# Appendix J    Comments on the Draft EIS

**Cascabel Working Group response to the Draft Environmental Impact Statement for the proposed SunZia Southwest Transmission Project, with Emphasis on Subroutes 4A and 4B**

**COMMENTS ON THE DRAFT ENVIRONMENTAL IMPACT STATEMENT AND RESOURCE  
MANAGEMENT PLAN AMENDMENTS FOR THE SUNZIA SOUTHWEST TRANSMISSION PROJECT  
WITH SPECIFIC REFERENCE TO THE SAN PEDRO VALLEY**

**Figure 1.** Impact of the SunZia preferred alternative on the acquisition envelope (dashed green line) for the Lower San Pedro River National Wildlife Refuge, proposed as part of the U.S. Fish and Wildlife Service's current Lower San Pedro River Valley Collaborative Conservation Initiative.

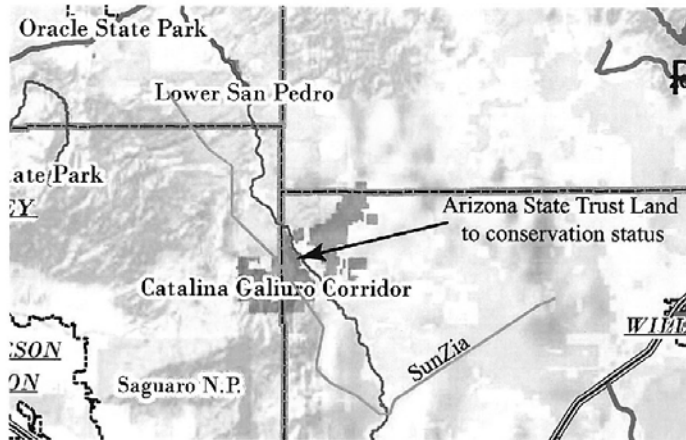
**3** This route seriously impacts the U.S. Fish and Wildlife Service’s current Collaborative Conservation Initiative for the Lower San Pedro River Valley (Figure 1). The route closely parallels the acquisition boundary for a new wildlife refuge for nearly the entire length that the route is in the valley. The federal government is working at cross purposes with its own conservation initiatives here.

- 3** Although the preferred alternative route would cross and parallel the area delineated as the Collaborative Conservation Initiative for the Lower San Pedro Valley (Figure 1), the route would closely parallel the existing two, 345 kV transmission lines near the (Narrows) river crossing, which would avoid serious impacts to, or conflicts with, conservation values or lands within the area.

**Figure 2.** Impact of the SunZia preferred alternative on Arizona State Trust Land being considered for inclusion in conservation status in Arizona State Trust Land Reform initiatives (dark blue areas). The blue irregular line is the San Pedro River.

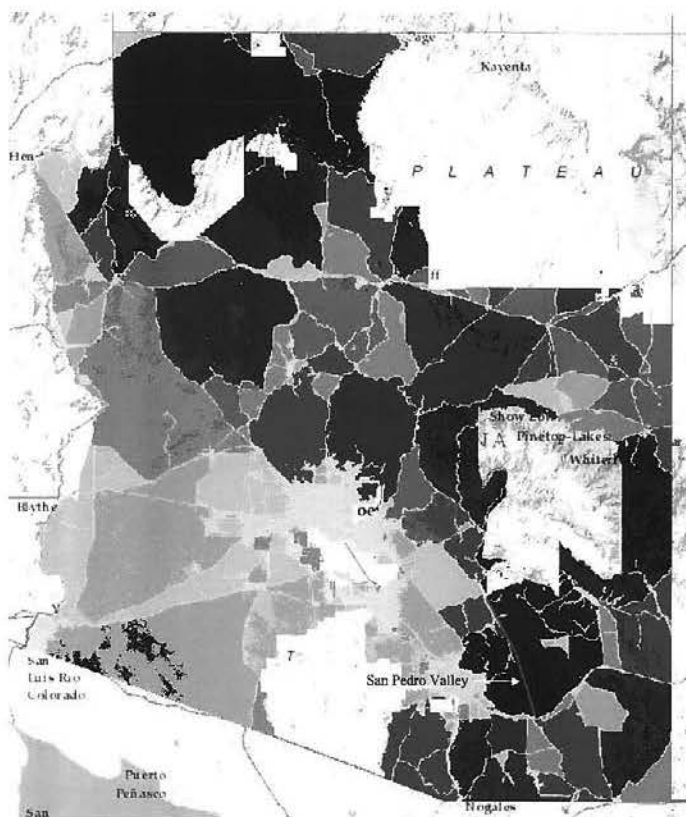
**4** In addition, the preferred alternative must cross the Catalina/Rincon-Galiuro corridor that has been part of an Arizona State Land Reform initiative for several years. This proposition seeks to conserve these Arizona State Trust lands in the San Pedro Valley for conservation purposes in perpetuity. The preferred alternative must bisect these lands (see Figure 2).

- 4** As stated, the preferred alternative route would cross the Catalina/Rincon-Galiuro corridor. Although these lands had been considered part of the State Land Reform initiative at one time, they are composed of primarily Arizona State Trust lands, leased for grazing, and have not been designated for conservation purposes by the Arizona State Land Department.
